**UNITED STATES ENVIRONMENTAL PROTECTION AGENCY  
REGION 10**

Re: The Environmental Protection Agency's comments on the Lower Snake River Programmatic Sediment Management Plan Draft EIS. EPA Project Number 05-055-COE.

**EPA Detailed Comments on the  
Lower Snake River Programmatic Sediment Management Plan  
Draft Environmental Impact Statement**

**Figure 1.** Relative suspended sediment loads of the Lower Granite sediment yield watershed  
[i.e., Figure 151 in Appendix F]

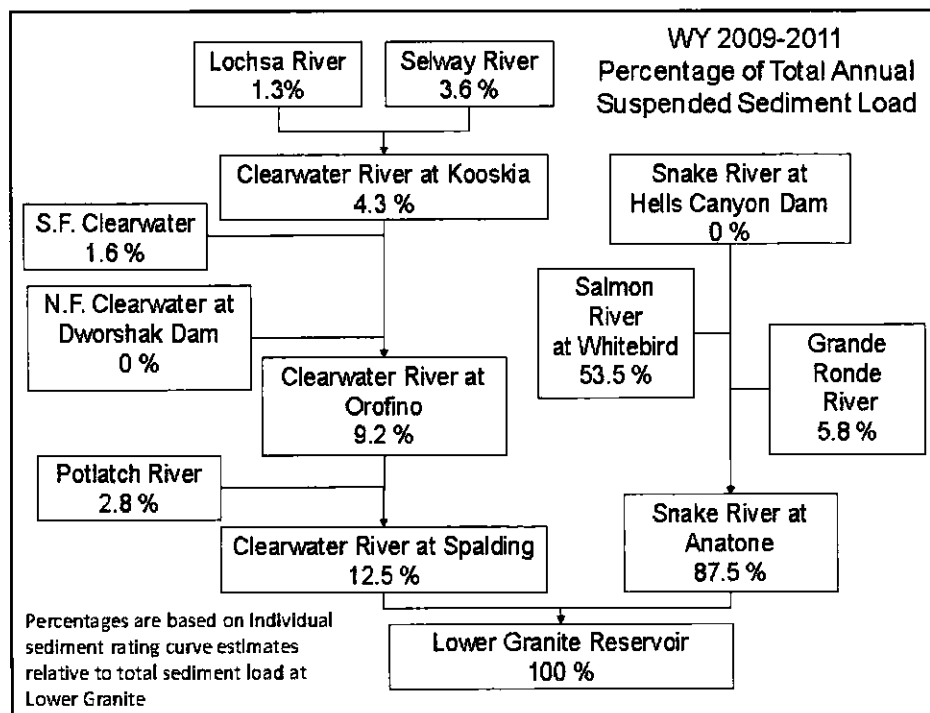
The mass balance presented in the DEIS does not identify the source(s) of between 21% and 33% of the sediment load that reaches the Lower Granite Reservoir.<sup>12</sup> This 'unknown' sediment load adds a level of uncertainty to the watershed analysis presented in the DEIS. Accordingly, based on the uncertainty associated with the 'unknown' component of the mass balance it would be prudent to continue monitoring watershed sediment processes in order to determine the source of this 'unknown' sediment, with a goal of developing watershed sediment management of the 'unknown' sediment source(s) along with the 'known' sediment sources.

**Figure 1.** Reported “Event” and “Chronic” Sediment Loading Studies

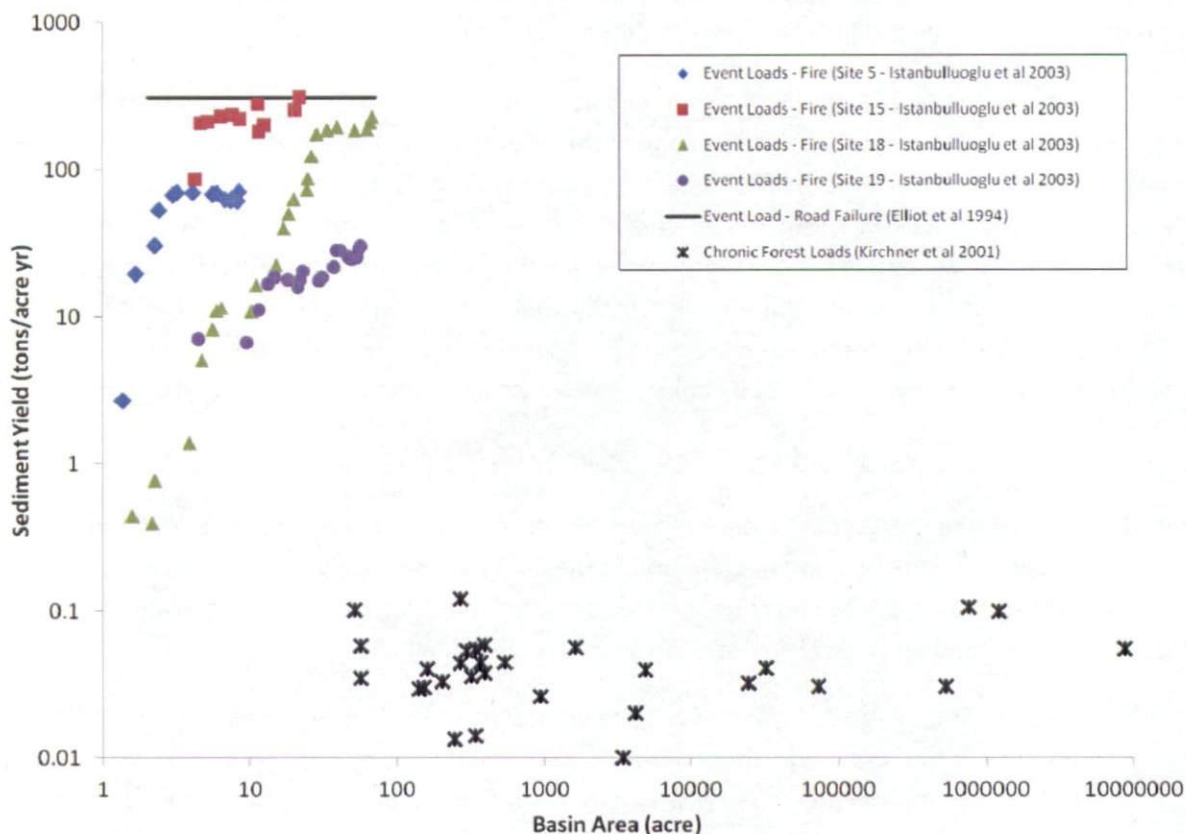
The information contained in the above listed sentences is correct; however it is incorrect to conclude that roads are not a potentially important source of sediment load. That is, it was reported in Appendix C that problems with **forest roads** can also cause very large 'mass-wasting' events, independent of the fire regime. For example, it was reported on page 10 of Appendix C that during the 1995/1996 storm event, 35% of the total estimated landslide volume in the Clearwater National Forest was from roads with 25% of the total estimated volume delivered to streams was from roads.<sup>2</sup> The amount of sediment

The DEIS correctly indicated that chronic loading of sediment from surfaces of forest roads is much lower than loading levels associated with ‘mass-wasting’ events (See black “X” marks in **Figure 1**). Accordingly, it would not be inconsistent to find that it would be difficult to observe statistically

**Figure 2.** Trapper Creek sampling locations #18 and #15 (Istanbulluoglu et al. 2003)  
[The red dot is the approximate downstream location, and yellow line is the contributing area]

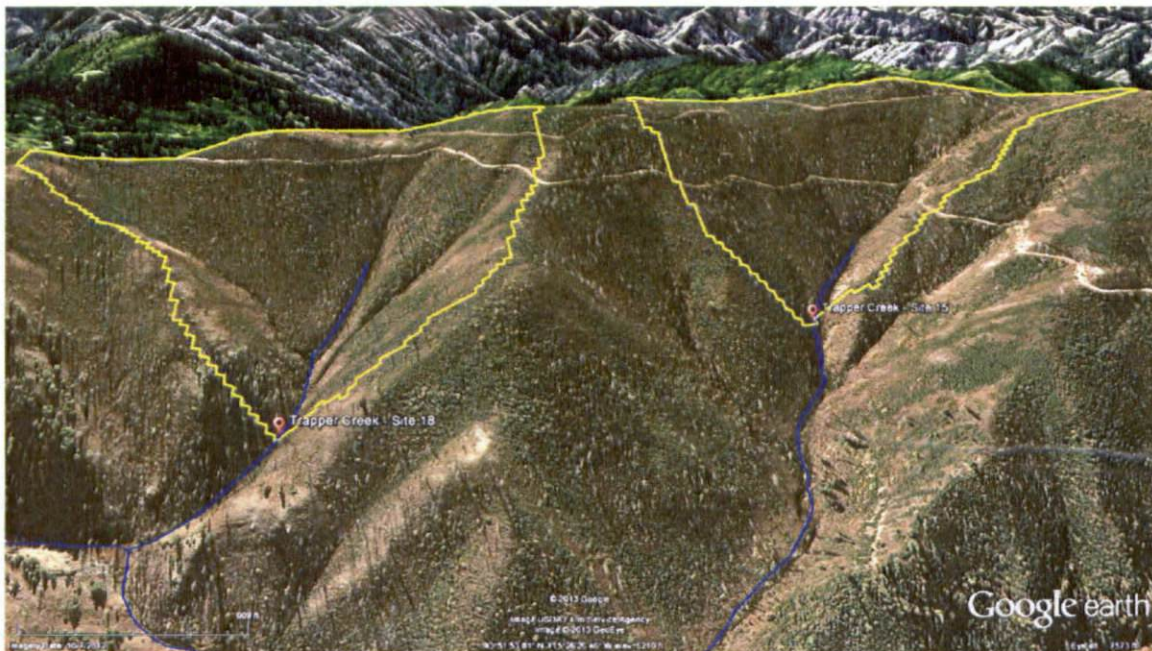
Forest roads, or any other land management activity (e.g., forest harvest), may not by themselves lead to a large sediment loading event, but they could become problematic if these conditions are associated with other disturbance events (e.g., fire). For example, on closer examination of the sites associated with the fire induced ‘event’ sediment loads illustrated in **Figure 1** (i.e., the Istanbulluoglu et al. 2003 study), it is hard to determine if fire is the only cause of the channel scour events associated with these four sites because there are several roads located in close proximity to observed channel scour associated with these sites (**Figures 2 through 4**).<sup>3</sup>

**Figure 5.** Horse Creek sampling location #10 (Kirchner et al. 2001)

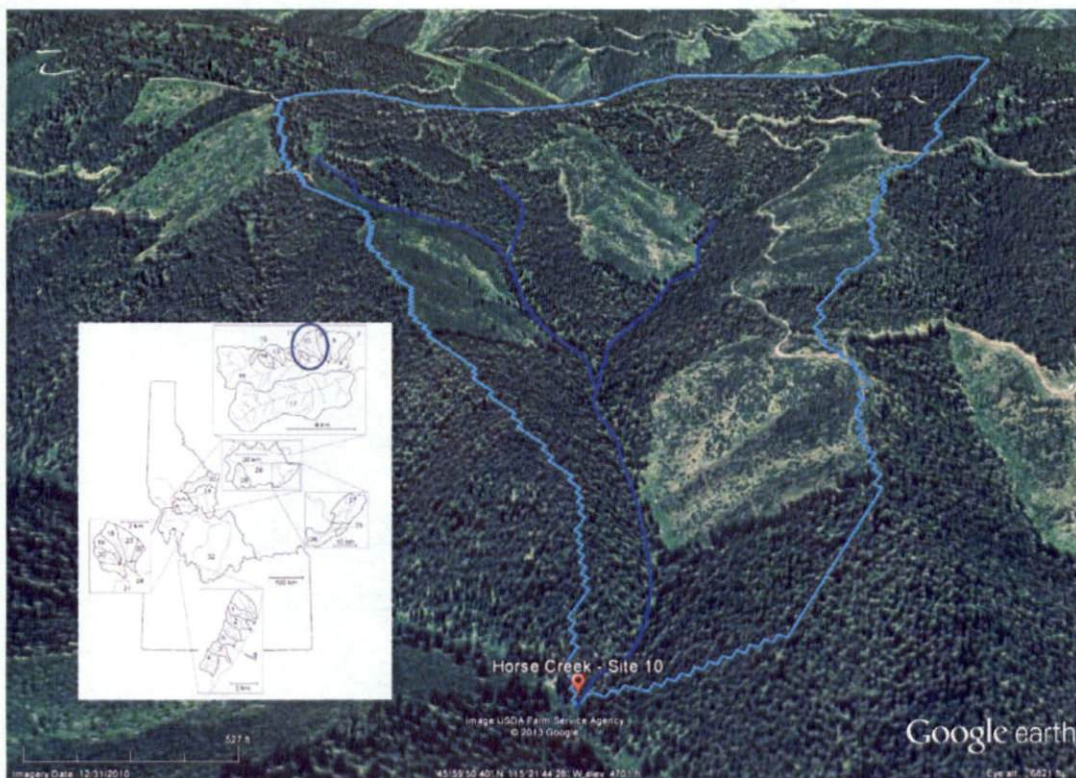
Presented below is an image of one of these watersheds which might be considered as "roaded" within the Kirchner et al. 2001 study (**Figure 5**).<sup>5</sup> Three things can be seen in this image. First, the distance between forest roads and the sampling location is relatively far and, in addition, the roads are not located near the stream channel (indicated by the blue lines), which can reduce the potential sediment loading to a stream. There may be other watershed land management characteristics which would have produced completely different results (e.g., roads located near the stream channel, and the roads are located on steep slopes, and the roads are in some sort of disrepair). Accordingly, there may situations when sediment loading from chronic sources (e.g., roads or clearcut harvest) will be measurable in the water column and stream bed material. Second, there are other potential sediment sources within the basin (e.g., forest harvest) which makes it difficult to separate out the effects of any of the potential sediment sources. Finally, although it is very hard to determine from the photo, it does not appear that there are any 'mass-wasting' events associated with either the roads or harvest activities within this basin.

<sup>5</sup> Visual inspection of the other "roaded" watersheds associated in this study indicates that this site is representative of the other sites.

**Figure 1. 2006 NLCD grid for the Potlatch River Basin**  
[Figure 159 in Appendix F]

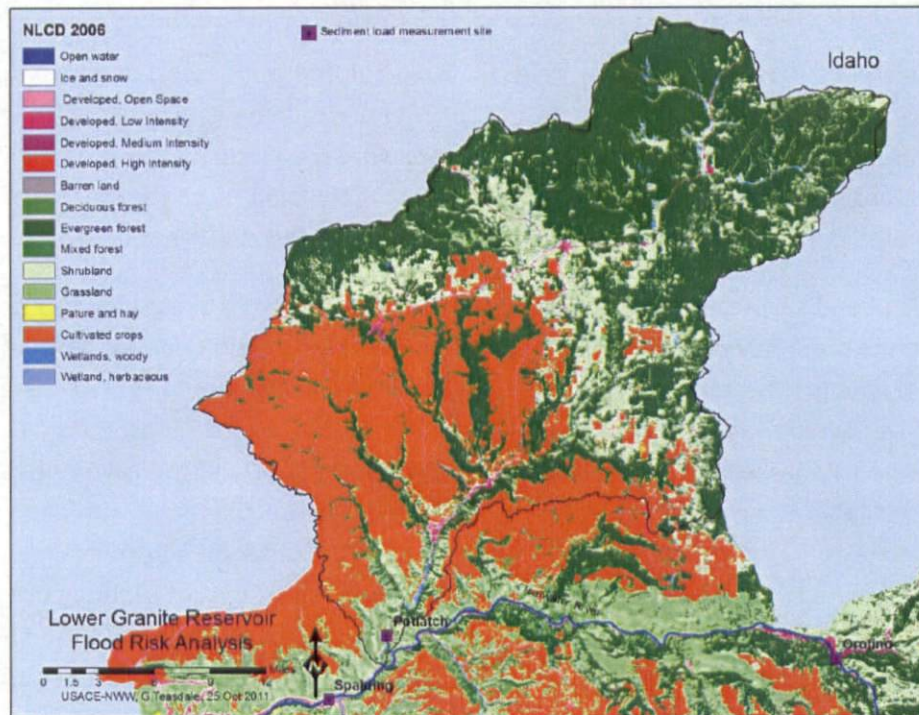
The reported sediment yield for the Potlatch Basin (i.e., 0.25 tons/ac/yr) is a function of loads from both agricultural lands and forested lands within the Potlatch watershed. Sediment yield for non-agriculture areas were assumed to equal the average **measured** condition reported for 30 forested Idaho basins (i.e., 0.05 ton/ac/yr)(Krichner et al., 2001). Accordingly, the proportional “sediment yield from agricultural lands” in the Potlatch Basin can be estimated using the following equation:

Figure 2. Sediment Delivery Ratios for various watershed sizes, based on Vanoni (1975).

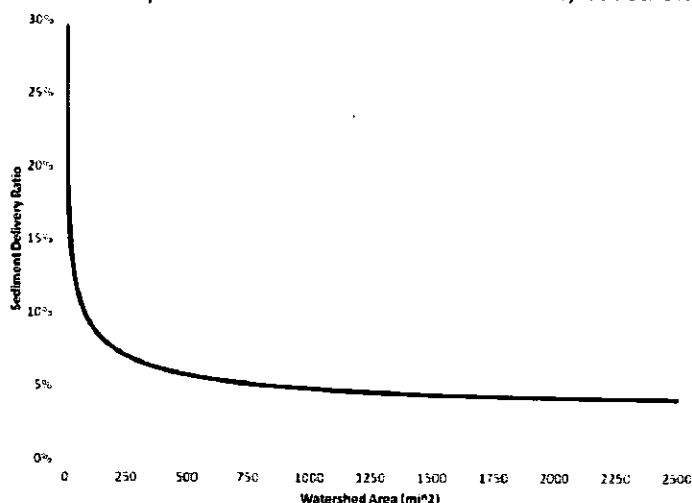
SDR values developed in Appendix E were derived for the entire watershed area, while agricultural land use comprises only a fraction of the watershed area. Accordingly, it appears that the calculated SDR used in the original analysis were overestimated. As mentioned previously, SDR values were used to estimate the amount of the RUSLE2 derived sediment that would reach a downstream watershed location. SDR should be calculated by area of agricultural use, and not the entire watershed area. It is important to point out that agricultural areas are often located in lower portions of the watershed, near water sources and tend to be located on flat land areas, while forested areas are generally located in upper watershed areas (see Figure 159 from Appendix F and presented above). Accordingly, including the upslope forest areas during SDR calculations dilutes the potential delivery of sediment from agriculture lands (i.e., doing so assumes that the upslope forested areas have an effect on the agricultural load near the watershed mouth). Using the modified SDR values, estimated sediment yield from agricultural areas increased from 0.13 to 0.18 ton/ac/yr (Table 5).
